SLUP-6  
(2014)

ROSWELL ROAD SELF STORAGE

REZONING SITE PLAN

### **SLUP-6      3700 ROSWELL ROAD, LLC**

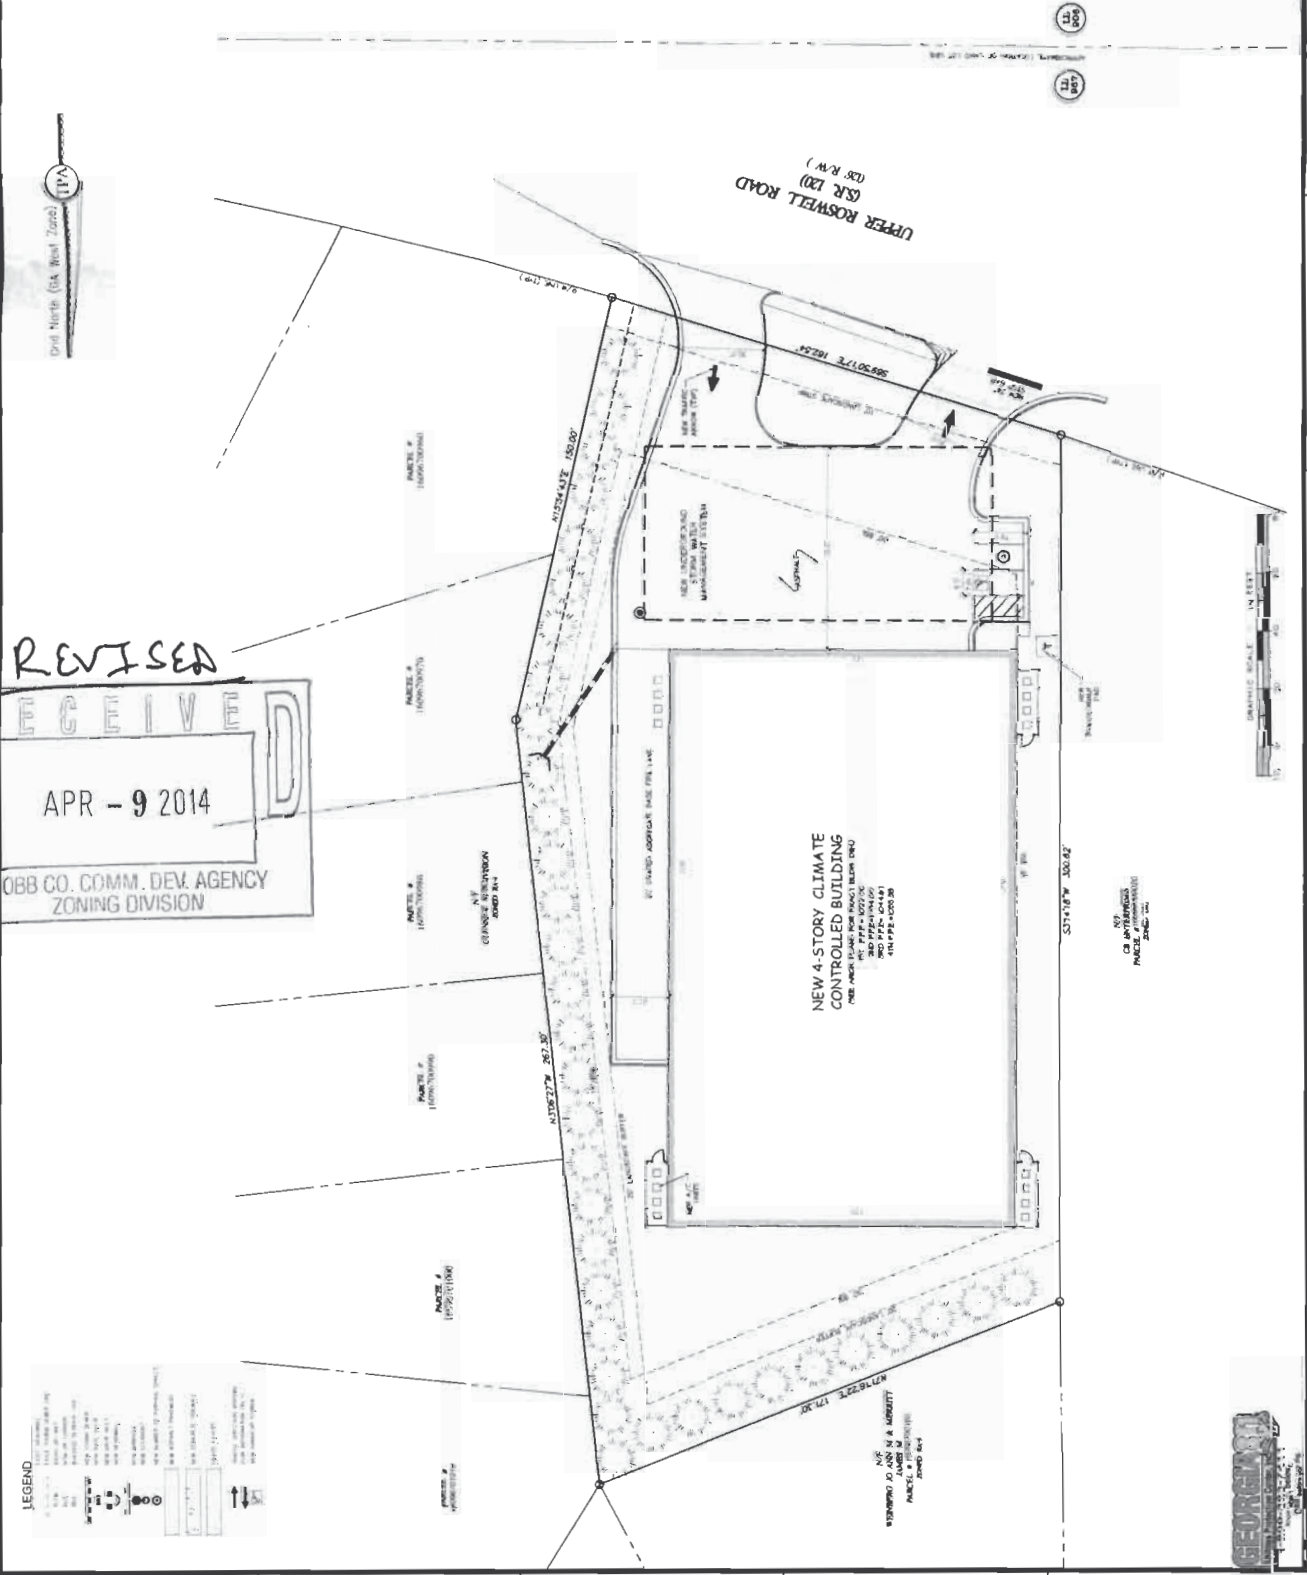
The proposed building height of 51’8” is much higher than those residences immediately located to the west of the subject site. This could be seen as contradictory to the Code’s minimum standards of “(not) impact the view shed of adjacent residential property.” Also, the proposed floor to area ratio (FAR) is 1.55, well over the 1.0 suggested by the Code. While all units are accessed internally, it is not clear from the applicant’s submissions if all windows are “one way” as prescribed by the Code. Too, the Code requires that “architectural style/design to be similar or complementary to the predominant architectural design of other commercial uses within the activity center.” The proposed architecture of the storage facility appears more modern with expanses of EIFS, glass, metal accents and modular brick veneer while nearby office uses within the activity center of this portion of Roswell Road and Robinson Road are of a more traditional style of brick construction. A minimal landscaping plan has been provided which shows a 20 foot landscape buffer adjacent to the residential properties to the south and west as well as landscaping of the frontage.

- Provide comprehensive hydrology/stormwater controls to include development of out parcels.
- Submit all proposed site improvements to Plan Review.
- Any **spring activity** uncovered must be addressed by a qualified geotechnical engineer (PE).
- Structural fill \_\_\_\_\_ must be placed under the direction of a qualified registered Georgia geotechnical engineer (PE).
- Existing facility.
- Project must comply with the Water Quality requirements of the CWA-NPDES-NPS Permit and County Water Quality Ordinance.
- Water Quality/Quantity contributions of the existing lake/pond on site must be continued as baseline conditions into proposed project.
- Calculate and provide % impervious of project site.
- Revisit design; reduce pavement area to reduce runoff and pollution.

- No Stormwater controls shown \_\_\_\_\_
- Copy of survey is not current – Additional comments may be forthcoming when current site conditions are exposed.
- No site improvements showing on exhibit.

2. The proposed site plan shows the detention facility discharging to the existing drainage easement in the adjacent Glenside Subdivision to the west. The stormwater management design must evaluate and account for the existing conveyance capacity of this older system as well the volume impact on the existing subdivision detention pond. As an alternative the site could be discharged to the existing stormwater system in the Roswell Road R/W subject to the available capacity. The final discharge point must be decided in Plan Review.

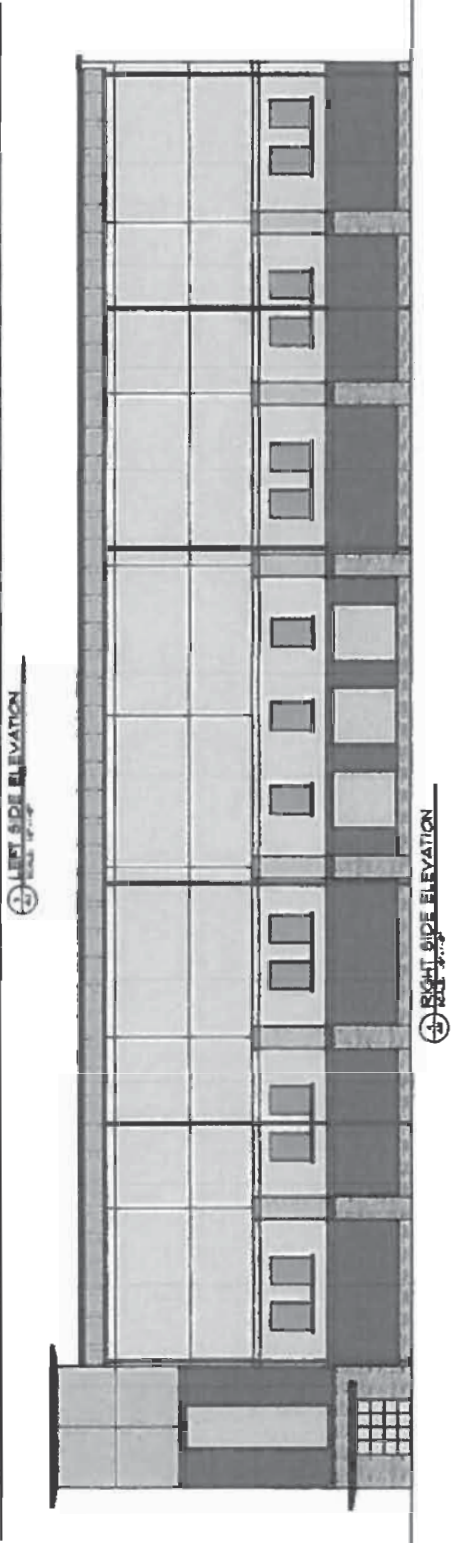
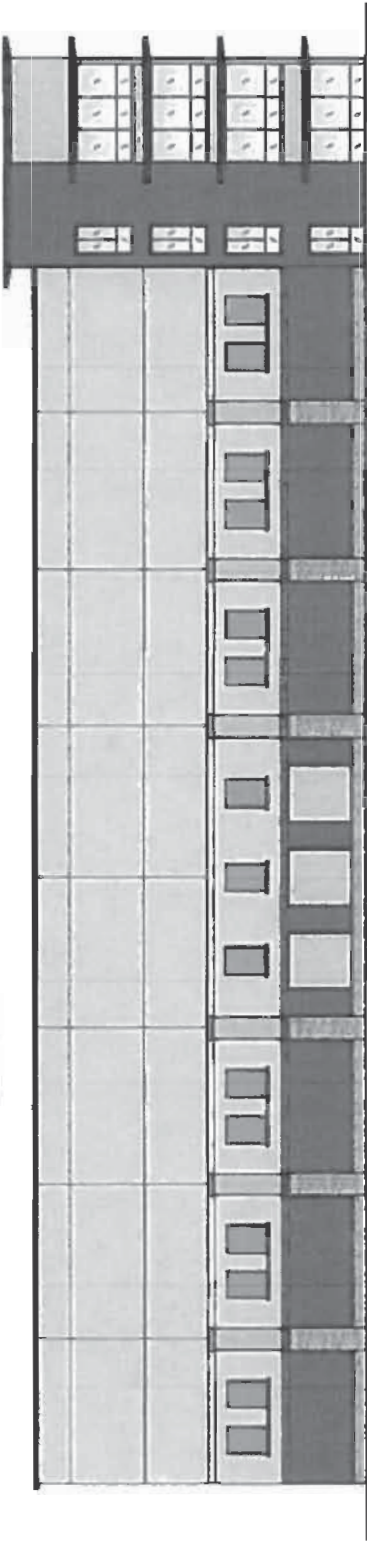
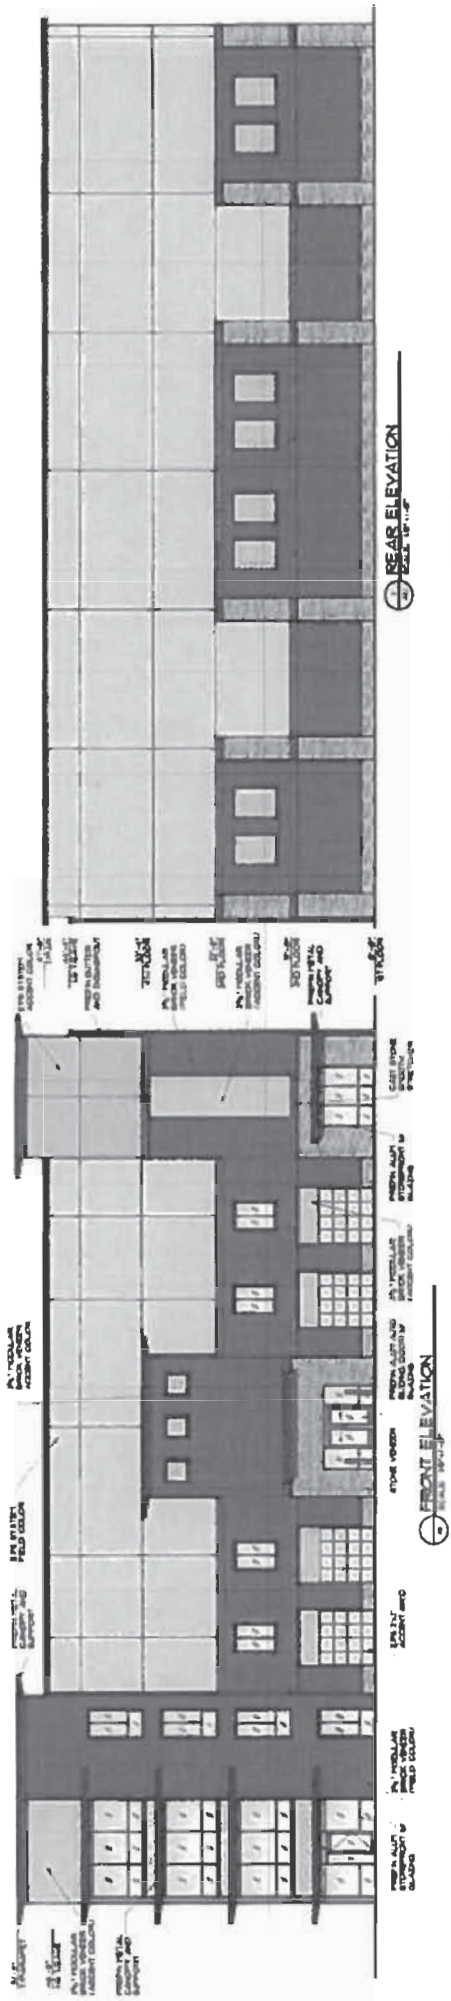
2. The architectural style, composition and design of the proposed building shall be in substantial conformity to the revised color rendering/elevation which is being submitted contemporaneously herewith. Said rendering/elevation depicts exterior materials on all four (4) sides consisting of brick and/or EFIS or a combination of both.
